Agenda
Village of Arlington Heights
Design Commission
Community Room, 3rd Floor

Arlington Heights Village Hall
33 S. Arlington Heights Road
Arlington Heights, IL 60005
March 31, 2015
6:30 PM

MINUTES OF
THE VILLAGE OF ARLINGTON HEIGHTS
DESIGN COMMISSION MEETING
HELD AT THE ARLINGTON HEIGHTS MUNICIPAL BUILDING
33 S. ARLINGTON HEIGHTS RD.
MARCH 10, 2015

A2.7

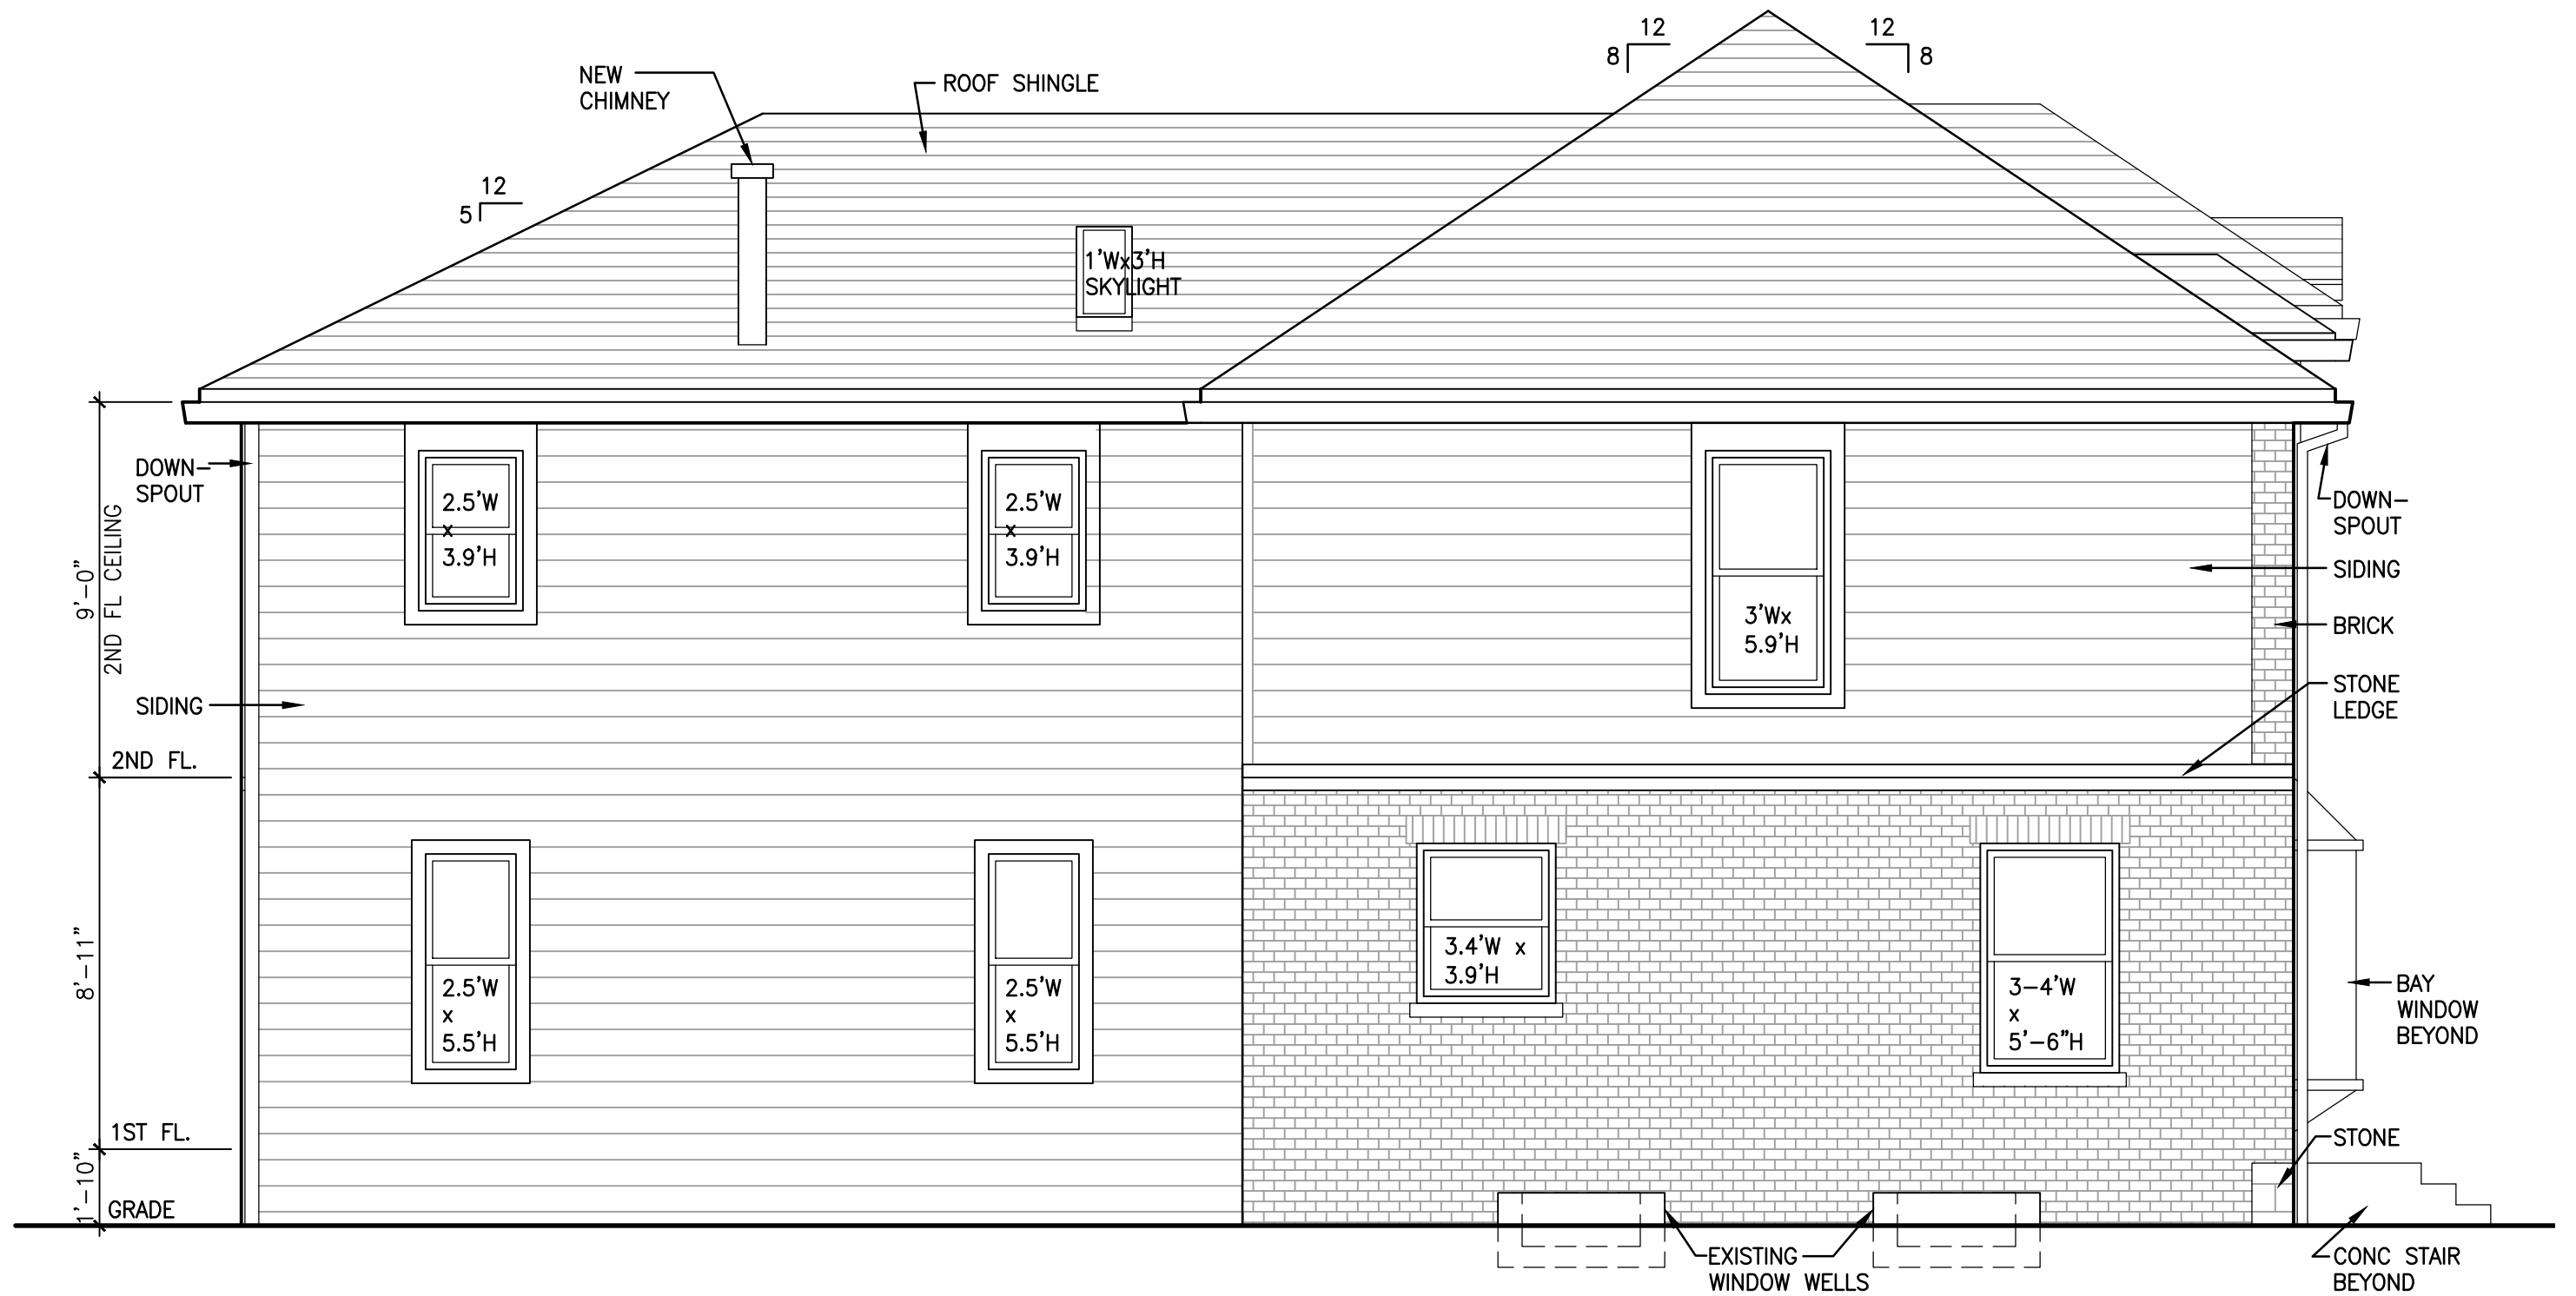
This project is a second floor and rear addition to an existing single story home, and it was previously approved on December 9, 2014 with a requirement, "to continue a horizontal trim board at the second floor line around all sides of the home." At this time, the house is under construction, and the petitioner is requesting approval to not add the horizontal trim board on the rear addition to the home, as well as to omit the horizontal stone trim band on all other sides of the home.

The stone band on the front elevation does help the design to relate to the adjacent single story homes, and the horizontal trim board on the rear addition helps to break up the two story wall of siding. However, this is a relatively minor detail on an otherwise nicely designed home.

Photo with actual lighting mock up

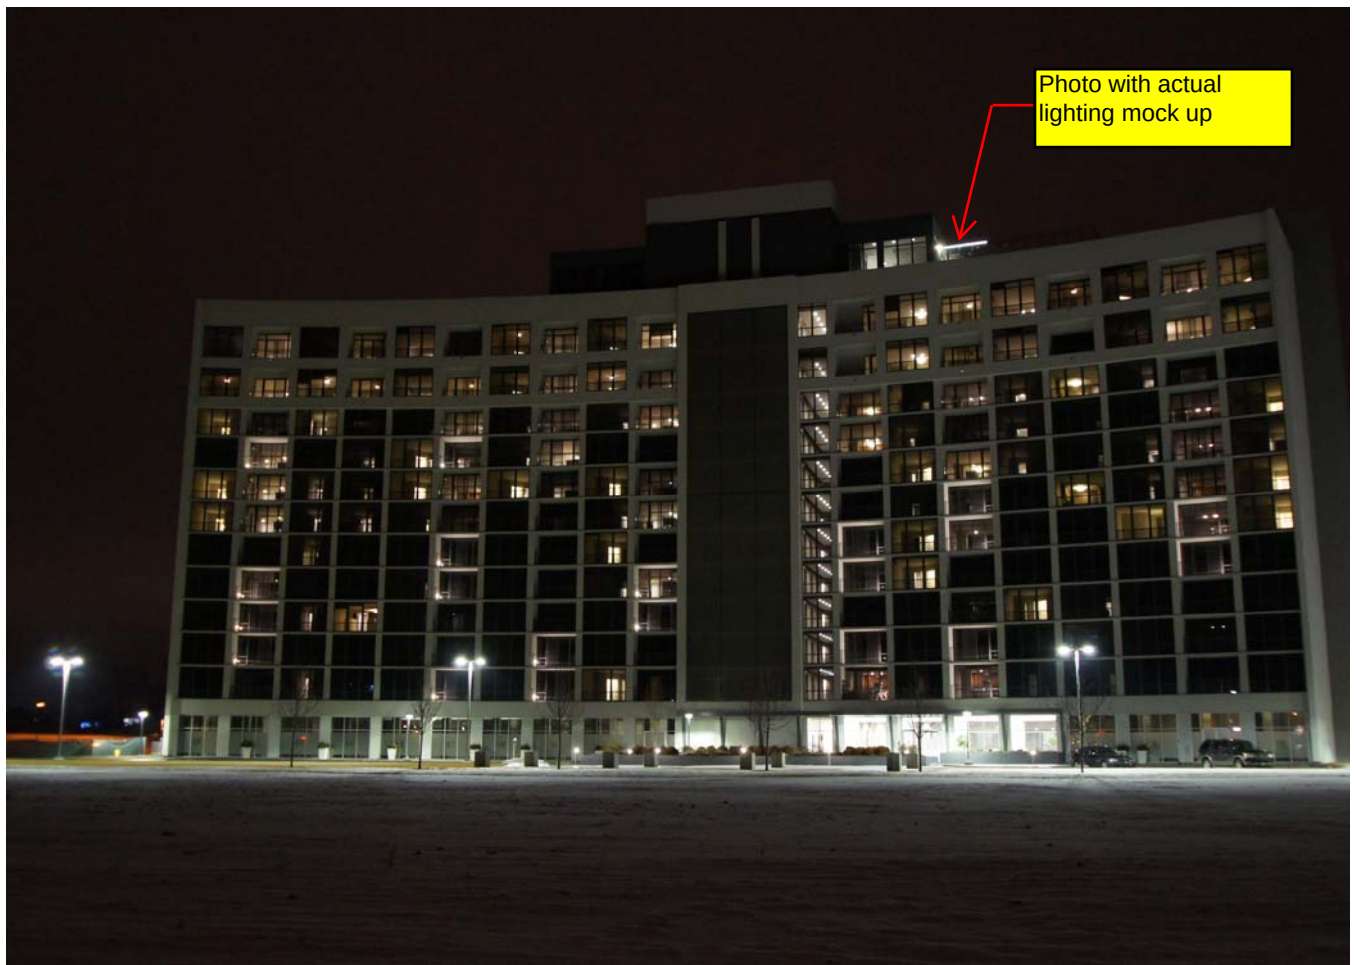
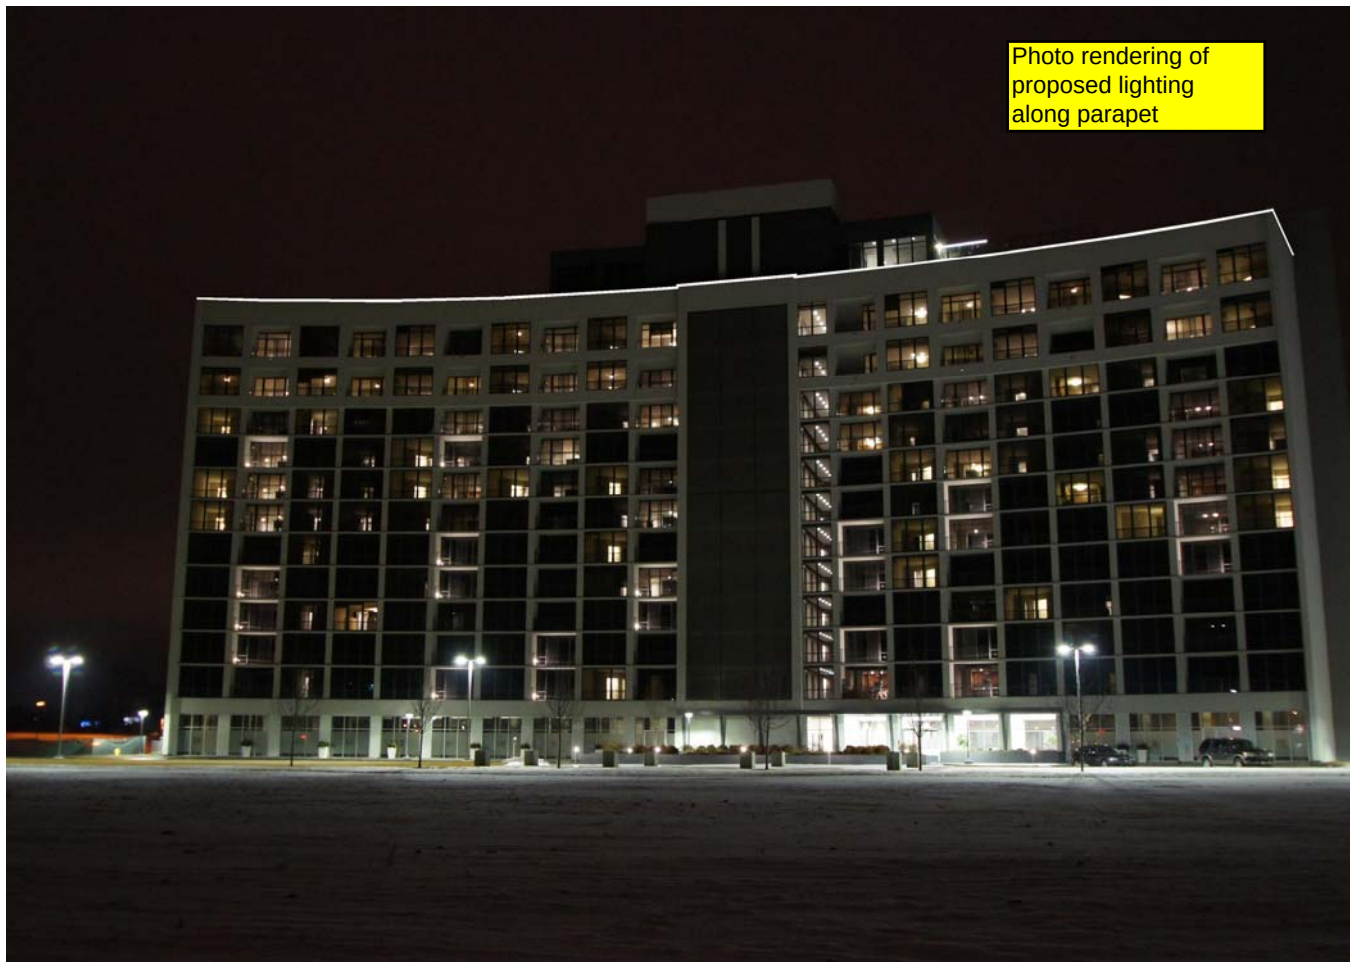
The issue with the proposed lighting is that, as proposed, the actual strip light will be exposed to direct view creating a crisp, bright line. The Village's Design Guidelines state that, "(Lighting) fixtures, standards and all exposed accessories shall be concealed..." Similar proposals in the past have been consistently required to conceal the light source from direct view, but the light can wash the building wall. It is recommended that the proposed installation details be revised to create a recess for the strip lighting to conceal the actual light source, but will allow the light to wash and highlight the building walls. However, since this is a tall building, glare from the exposed fixture is less of a concern than it would be for a similar proposal on a building at street level.
